**SUNDRY NOTICES AND REPORTS ON WELLS**  
*Do not use this form for proposals to drill or to re-enter an abandoned well. Use form 3160-3 (APD) for such proposals.*

8. Well Name and No.  
HH CE 35 02 FED 006 1H  
*multiple wells*

Summary: Variance to batch drill the HH CE 35 2 FED 006 not requested in the MDP nor original submittal.

Changes to APD FOR Federal Wells

# 6 well pad Bi-lateral Patterson Mock Pad

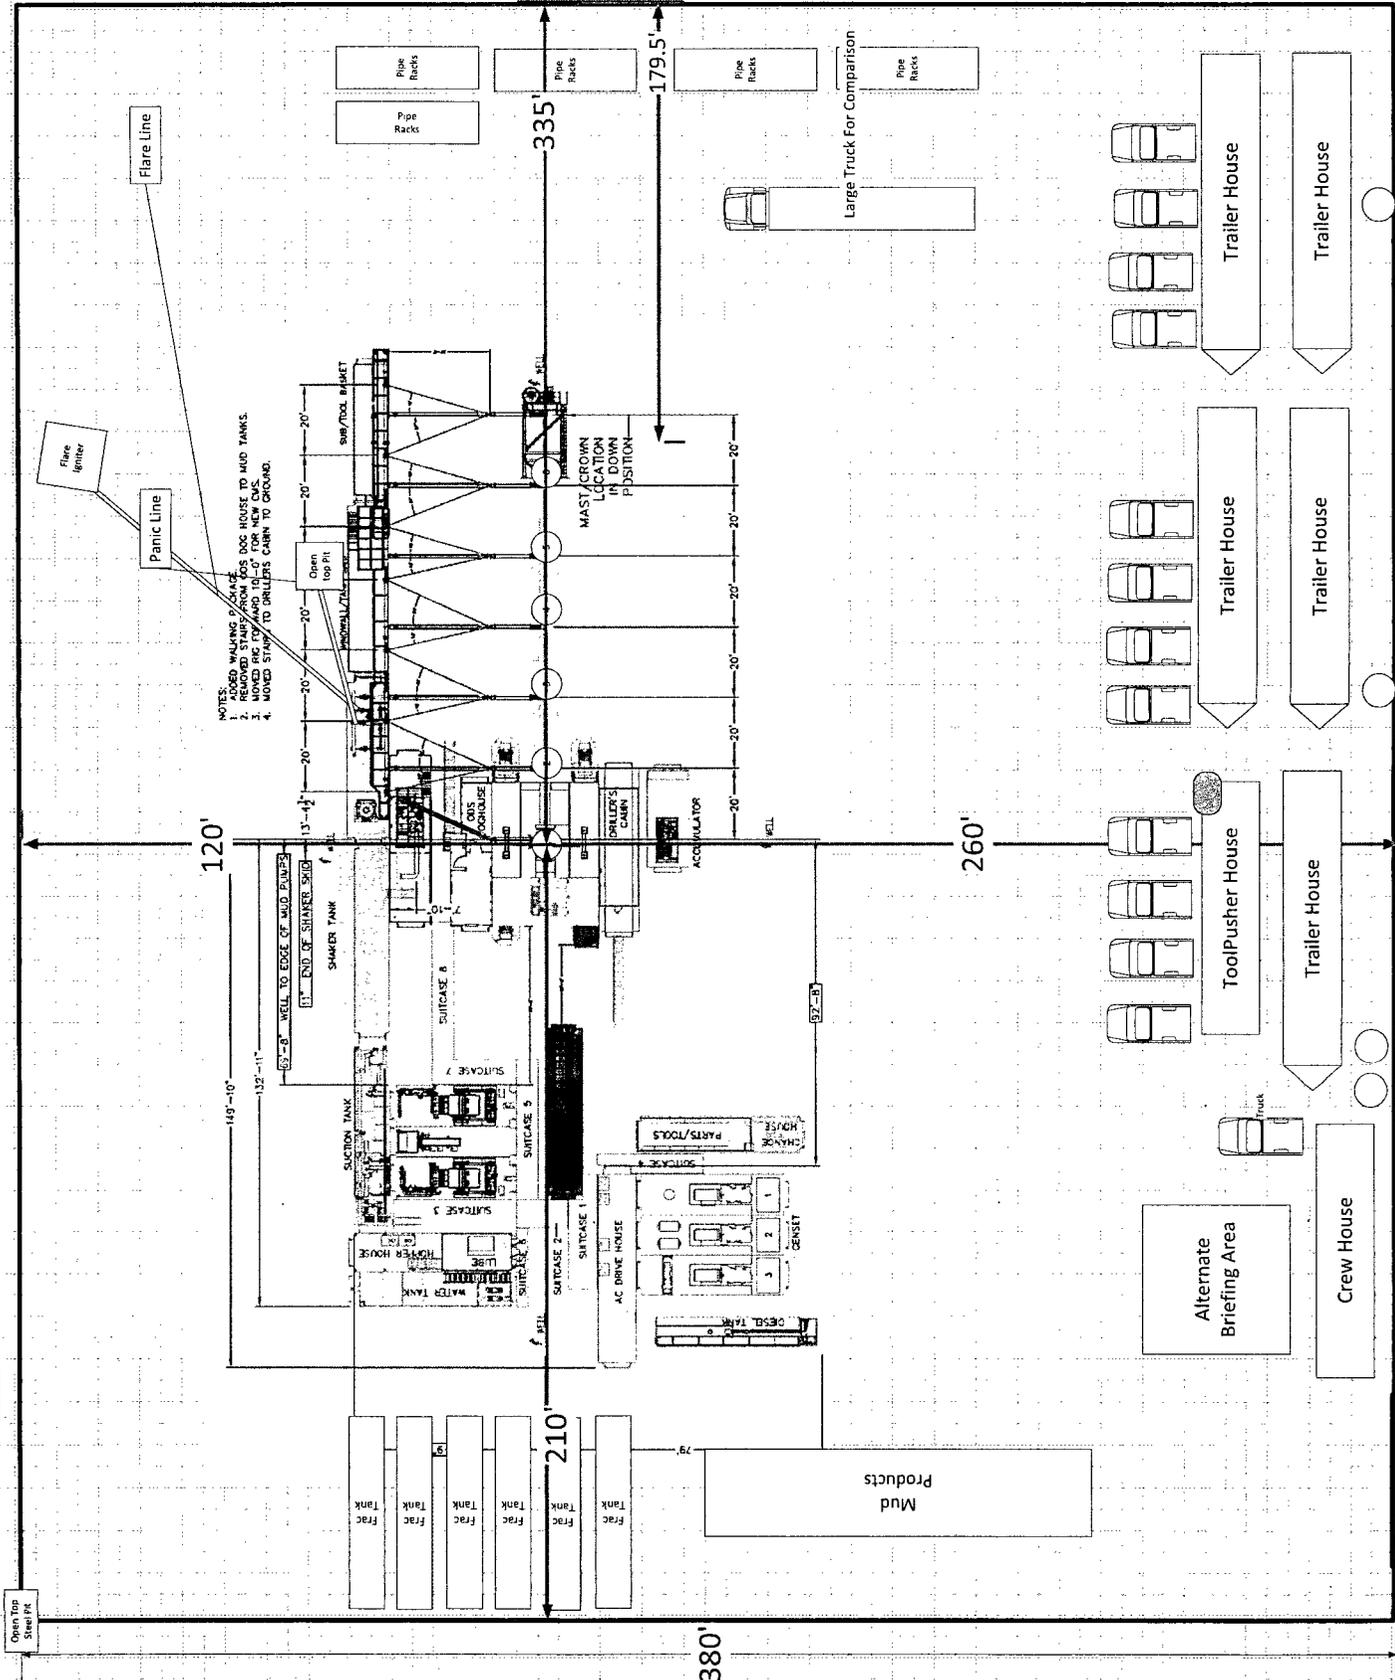
Rig layout shows rig in first and last well for illustration purposes.

- H2S Monitor Locations**
- Bop/Cellar
  - Rig Floor
  - Shaker Skid
  - Bell Nipple
- Flag Locations**
- Sign-in Shack
  - Rig Floor
  - Dog House
- 10 Minute Escape Packs**
- 1 at Pits
  - 1 at Trip Tank
  - 1 at Accumulator
  - 4 at Rig Floor
- 45 Minute Escape Packs**
- 2 at Briefing Area
  - 2 at Alternate Briefing Area
